This addendum forms a part of the Contract Documents and modifies the original Bidding Documents dated **July 21, 2021** as noted below. Acknowledge receipt of this addendum in the space provided on the Official Bid Form. Failure to do so may subject the Bidder to disqualification.

END OF ADDENDUM 1

Project: SCSD PARKING LOT UPGRADE

C0.01

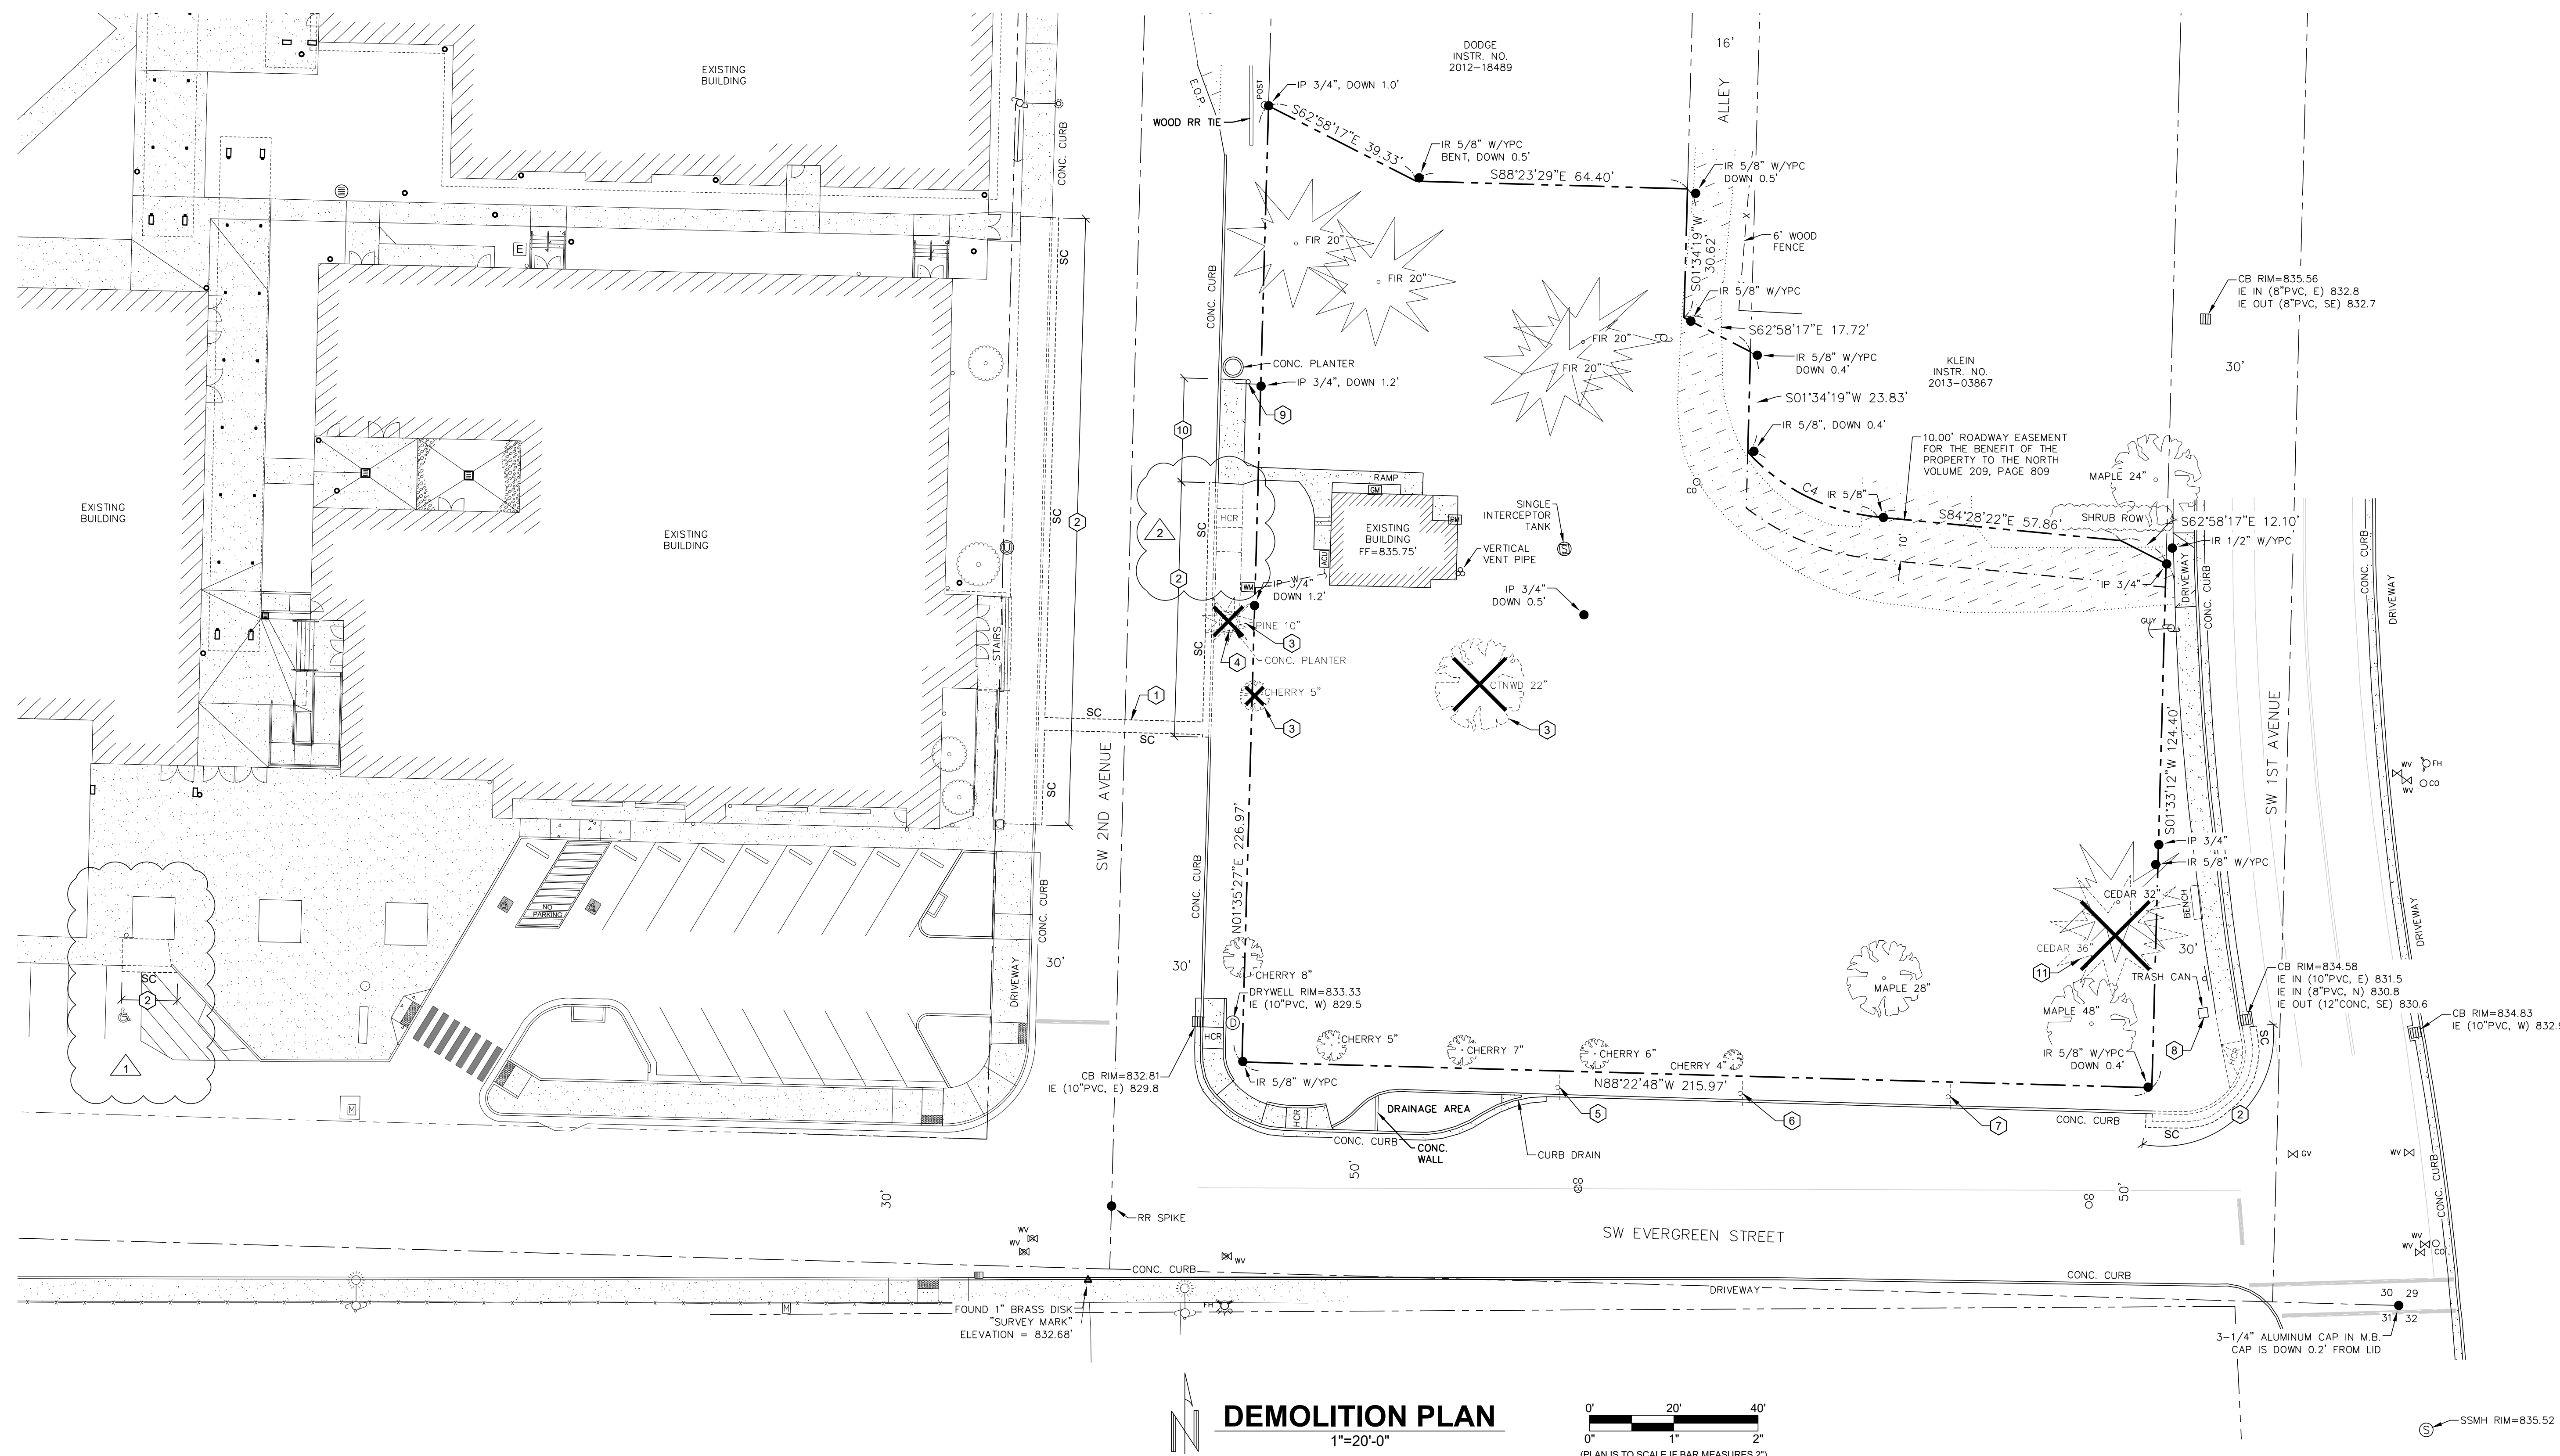
- REVISE per clouded items, Delta 2.

C1.03

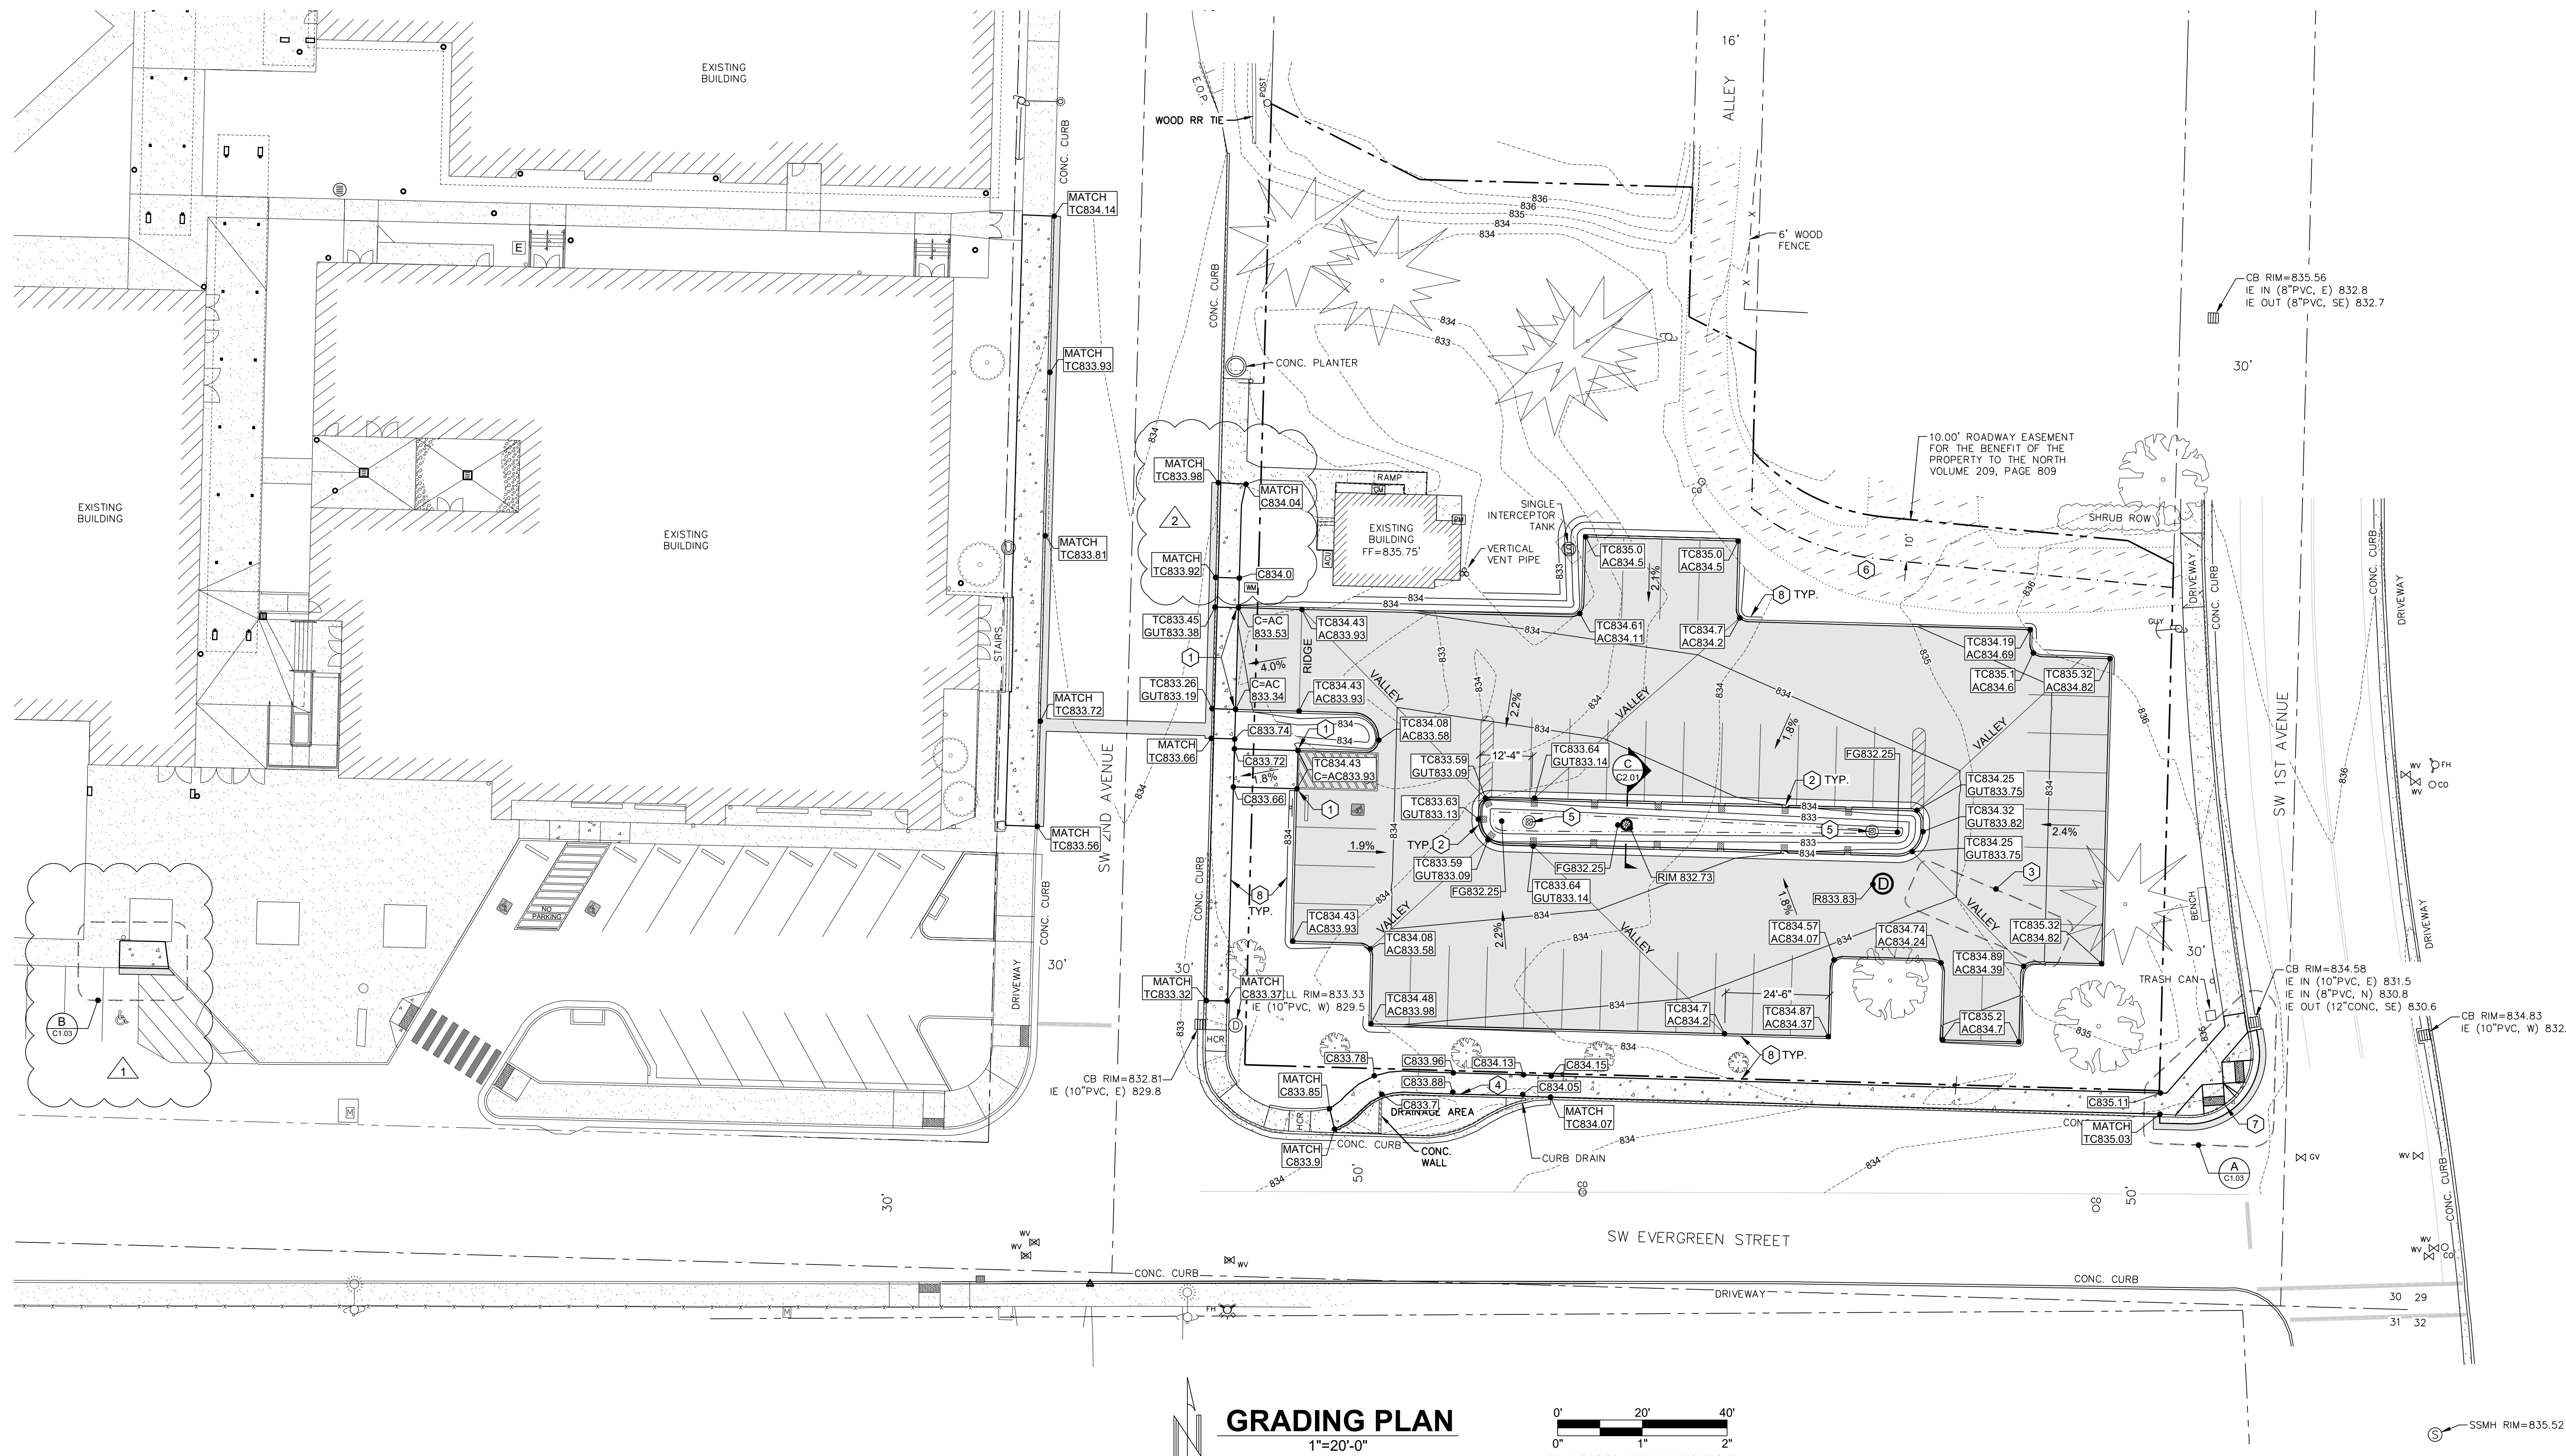
- REVISE per clouded items, Delta 2.
